# UNITED STATES PATENT AND TRADEMARK OFFICE

APPLICATION NO.	FILING DATE	FIRST NAMED INVENTOR	ATTORNEY DOCKET NO.	CONFIRMATION NO.
09/774,847	01/31/2001	Harald Krondorfer	1466	6258
7590 STRIKER, STRIKER & STENBY 103 East Neck Road Huntington, NY 11743			EXAMINER WEEKS, GLORIA R	
		ART UNIT	PAPER NUMBER 3721	
			MAIL DATE 12/12/2007	DELIVERY MODE PAPER

<b>Office Action Summary</b>	Application No.	Applicant(s)	
	09/774,847	KRONDORFER ET AL.	
	Examiner	Art Unit	
	Gloria R. Weeks	3721

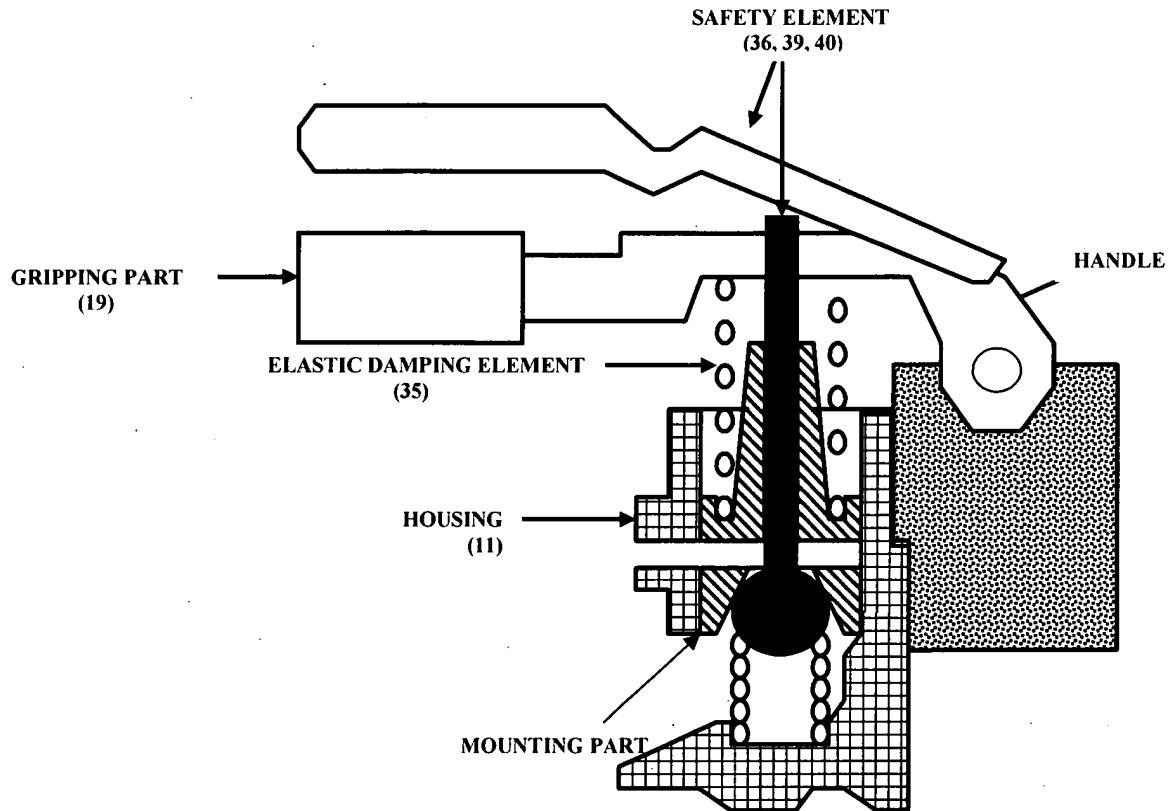
Regarding claims 11, 14-17, 19, 20 and 21, Johansson et al. discloses a hand power tool comprising: a housing 11; at least one handle having at least one gripping part 19; a mounting part (supports 40 within 35; see illustration below); at least one elastic, vibration damping element 35 mounted on the mounting part, the at least one gripping part 19 being mounted on the housing 11 through the elastic element 35 and through the mounting part; at least one movable rigid 36, 40 safety element and non-rigid safety element 39 through which the gripping part 19 is connected with the mounting part, the safety element 36, 39, 40 being movable relative to the gripping part 19 in at least a tilting direction 36 and a longitudinal direction 39, 40 during a predetermined operation relative to the gripping part 13 to avoid a passage of vibration through the safety element 36, 39, 40, wherein the elastic element 35 surrounds the safety element 40.

With respect to claim 24, Johansson et al. discloses, a hand power tool comprising: a housing 11; at least one handle having at least one gripping part 19; at least one elastic, vibration damping element 35; a mounting part (supports 40 within 35) on the elastic element (35; see illustration above); the at least one gripping part 19 being mounted on the housing 11 through the elastic element 35 and through the mounting part; at least one movable safety element 36.

Regarding claim 26, Johansson et al. discloses a hand power tool comprising: a housing 11; at least one handle having at least one gripping part 19; a mounting part (supports 40 within 35; see illustration above); at least one elastic, vibration damping element 35 mounted on the mounting part, the at least one gripping part 1) being mounted on the housing 11 through the elastic element 35 and through the mounting part; at least one movable and non-rigid safety element 36, 40 through which the gripping part 19 is connected with the mounting part, the safety element 36, 39, 40 being movable relative to the mounting part in at least a tilting direction 36 and a longitudinal direction 39, 40 during a predetermined operation relative to the gripping part 19 to avoid a passage of vibration through the safety element 36, 39, 40, wherein the elastic element 35 surrounds the safety element 40.

8. Applicant has argued that the push rod 40 of Johansson et al. cannot be defined as a safety element since no safety is provided by the push rod. Examiner has found the push rod 40 of Johnasson to indeed provide safety features, since one of ordinary skill in the art would define a trigger mechanism as a safety element. Such safety elements prevent unintended actuation of a tool in its state of rest or storage. As mentioned above, Examiner has broadly interpreted the term "connected" to be defined as joining or bringing together at least two objects to form a continuous unit. The portion 38 of the push rod (safety element) contacts the mounting part, and the push rod engages the lever 36, which is connected to the gripping part 19.
